Generic Design Assessment – New Civil Reactor Build

GDA Close-out for the EDF and AREVA UK EPR™ Reactor

**GDA Issue GI-UKEPR-IH-01 Revision 2 – Substantiation and Analysis of the
Consequences of Dropped Loads and Impact from Lifting Equipment included
within the EPR Design.**

Assessment Report: ONR-GDA-AR-12-016
Revision 0
December 2012

Figure 13: Section through the Containment illustrating the removal sequence for the Reactor Cavity Cover Slabs located above the Reactor Cavity Pool

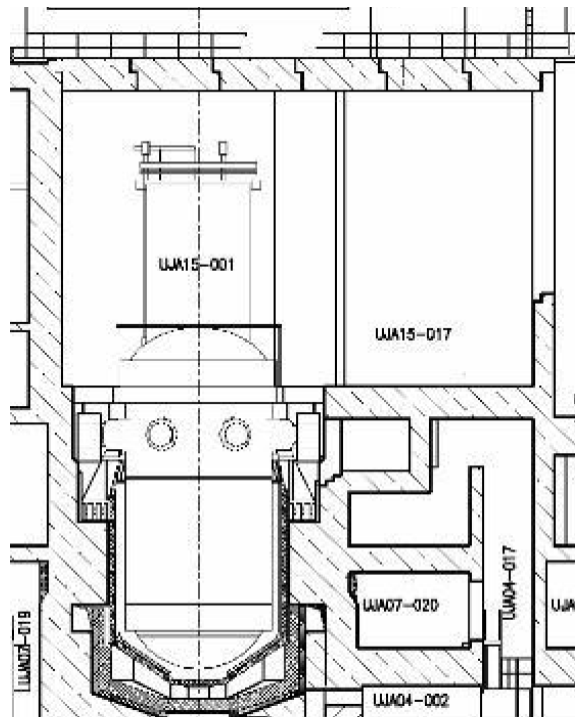
133 Figure 12 provides an illustration of the location of the slabs on the supports of the reactor cavity pool together with the locating lugs. It should be noted that Figure 12 is not represented correctly as it is not possible to remove the reactor cavity cover slabs before those over the Fuel Pool. Figure 13 illustrates a section through the Containment which shows how the slabs would be removed.

- 134 The analysis detailed within Reference 26 has considered the consequences of a dropped reactor cavity cover slab onto the reactor cavity floor slab and reported the outcome of the finite element analysis. The finite element analysis has not been subject to assessment as the calculations are associated with the civil engineering design of the structures which was subject to assessment during Step 4 of GDA by civil engineering assessors. The “*Step 4 Civil Engineering and External Hazards Assessment of the EDF and AREVA UK EPR™ Reactor*” (Ref. 38) identified an Assessment Finding that required the licensee to take account of any implications of the outcomes of the Internal Hazards GDA Issues which could affect the design of civil structures (**AF-UKEPR-CE-05**). The timescale for the finding is that it should be completed ahead of the placement of first structural concrete to ensure that there are no options foreclosed for mitigation of internal hazards as a result of concrete placed.

- 135 The following modifications (Ref. 11) were issued to ONR during the GDA close out for inclusion within the design reference (Ref. 9):
- CMF34, which relates to increasing the shear strength of the reactor cavity floor slab.

- 136 CMF34 states that the design change is required further to the analysis and I am satisfied that the CMF be included within the design reference (Ref. 9). CMF35 does identify further analysis work to be undertaken as part of the development of the modification, however, I am content that it can be included within the design reference (Ref. 9) given that the modification has been identified as being required.
